**CERTIFICATE OF APPROPRIATENESS**

**Property:** 7618 Glenvista St, lot 28, block 38, Glenbrook Valley Sec 7 Subdivision. The property includes a 2,055 square foot, one-story brick-clad single-family residence situated on an 8,103 square foot interior lot.

**Proposal:** Alteration – Remove three 6-over-6 and two 9-over-6 aluminum windows on the front of the non-contributing structure and replace with wood composite windows with internal muntins to match the existing lite patterns in the existing openings.

PROPOSED WINDOWS

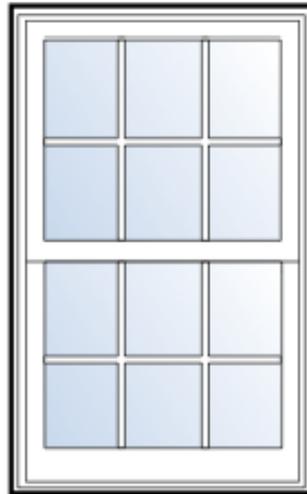
**7618 Glenvista:** The use of out of proportion vinyl framed windows for replacement of original aluminum framed windows is generally unacceptable.
